SCOPING OPINION:

Proposed Xlinks Morocco-UK Power Project

Case Reference: EN010164

07 March 2024

Figure 1 – Proposed Development location of the offshore cable corridor and landfall site, and Proposed Development scoping boundary. (Source: Applicant’s Scoping Report, pg.24).

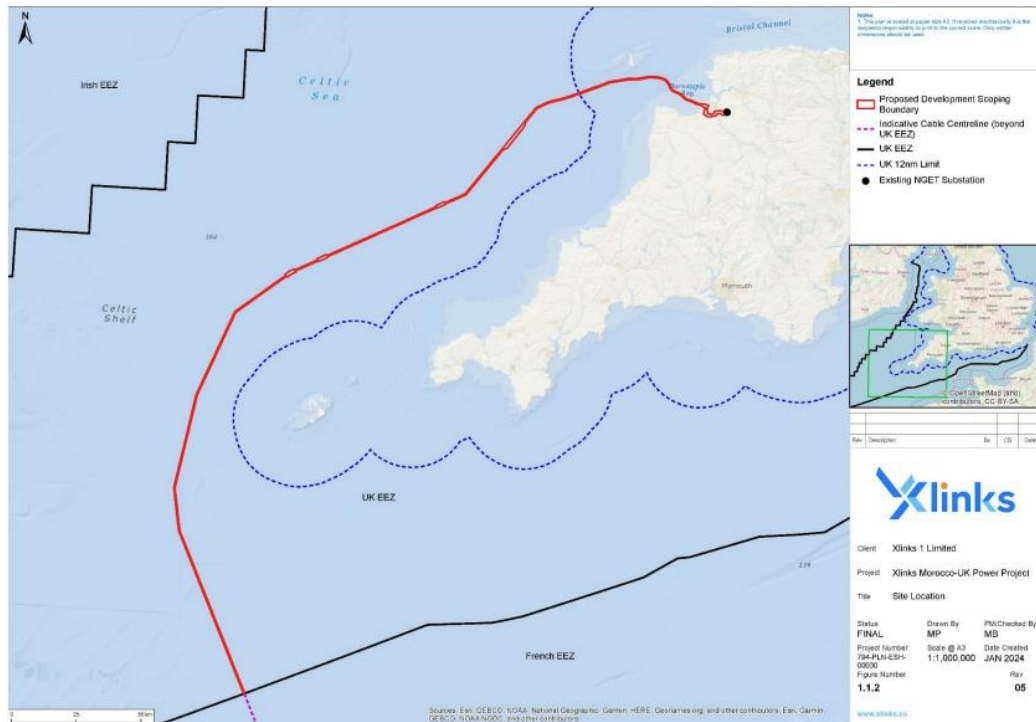
1.2.1 The proposed offshore cable corridor of the subsea HVDC cable is located within the Bristol Channel and Celtic Sea, extending from the landfall site at Cornborough Range on the North Devon coast to the limit of the UK EEZ, southwest of the UK (see figure 1).

Suggested Localised viewpoints:

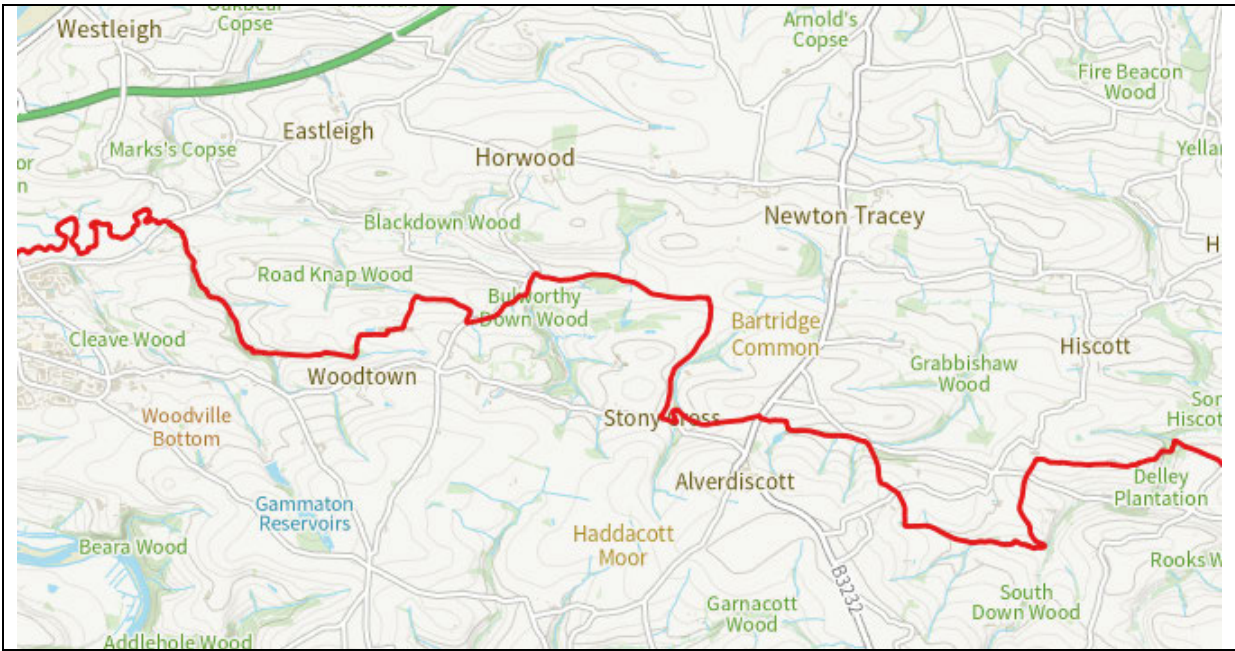
Localised viewpoints within the NDDC area in relative close proximity to the Substation site and the edge of the scoping zone:

Suggested Localised viewpoints are from:

- Hiscott,
- Newton Tracey,
- Horwood/Lovacott,
- Eastleigh

Suggested wider elevated viewpoints:

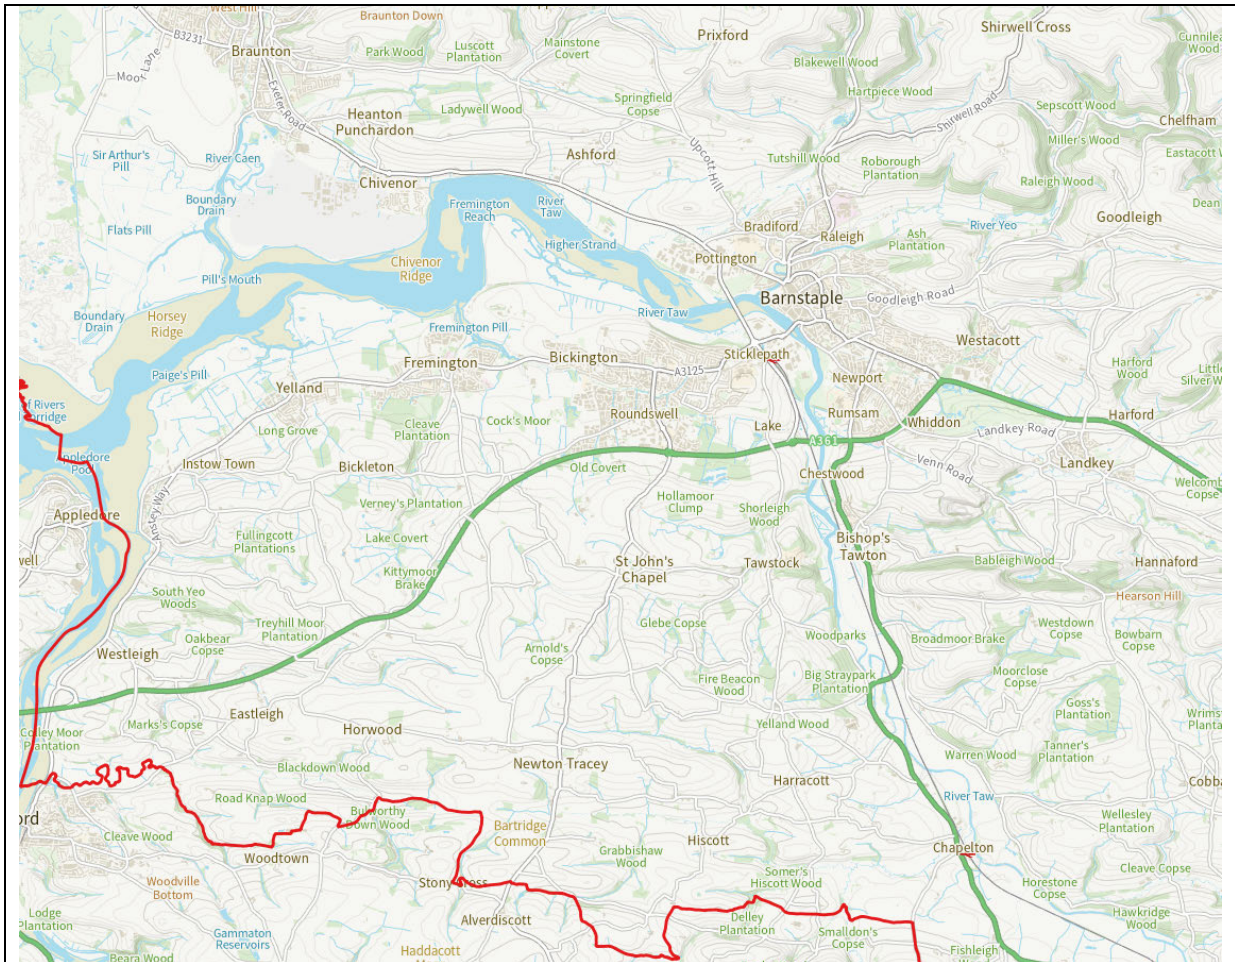
Wider elevated viewpoints within NDDC area:

Suggested wider elevated viewpoints are:

- Codden Hill (east)
- Ashford (North)

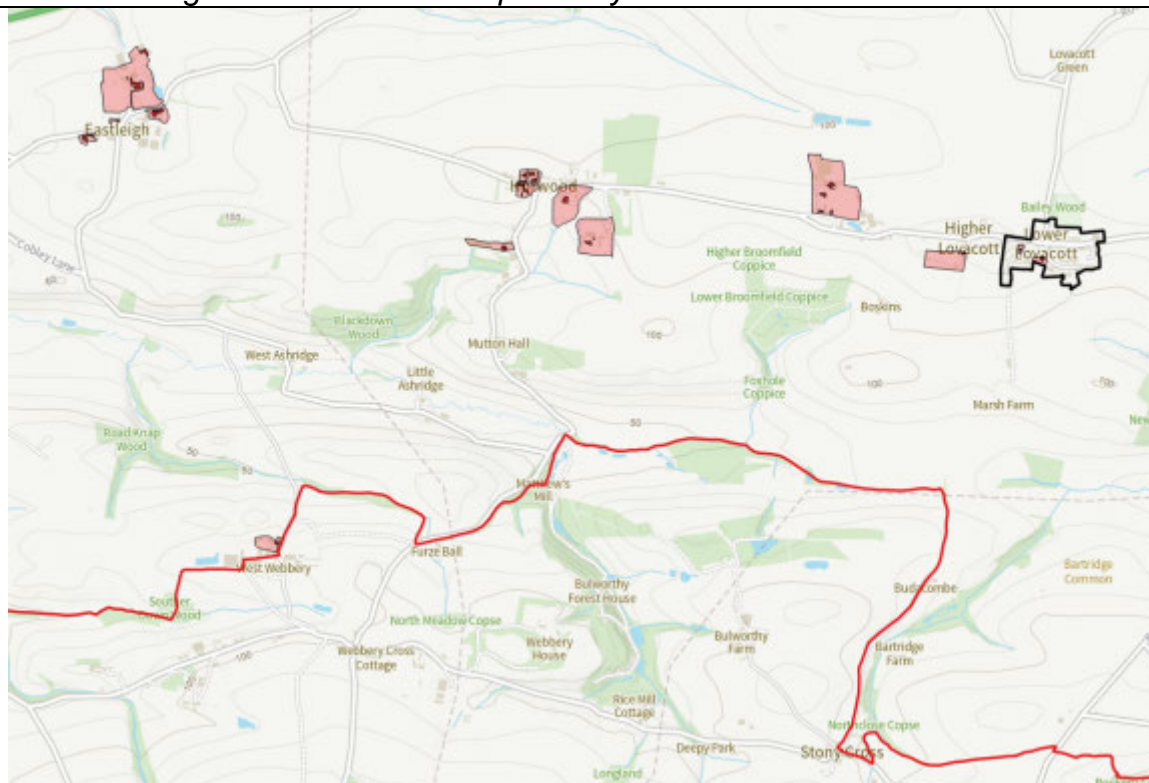
Suggested localised properties to take into consideration at consultation phase: within NDDC area:

- West Ashridge
- Little Ashridge
- Mutton Hall
- Eastleigh
- Oxenpark
- Horwood
- Newton Tracey (west)
- Higher Lovacott
- Lower Lovacott
- Higher Broomfield Coppice
- East Barton
- Properties around Potters Nod
- Harefield
- Marsh Farm
- Boskins
- West Barton House
- Park Farmhouse
- The Granary

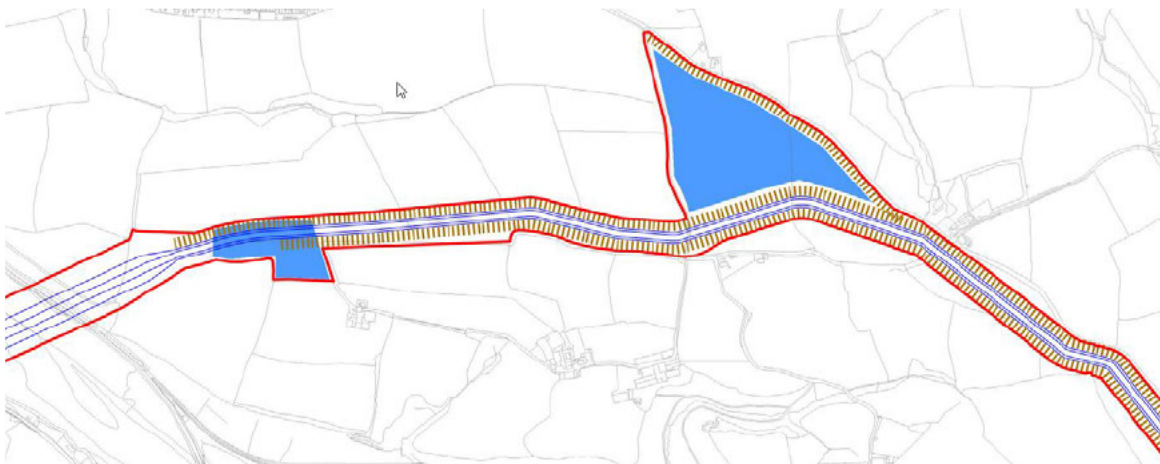
In this location the compound area at Abbotsham cross covers the site of a windmill identified in a heritage appraisal on the Clovelly Road South site and this will need to be recorded before any site disturbance.

The routing and compounds where the cable crosses the river has potential to impact on the view into Bideford, and the views from Landcross-Tennacott are visible from the A388. The level of visual harm to the views into Bideford will need to be assessed as part of a wider heritage assessment.'
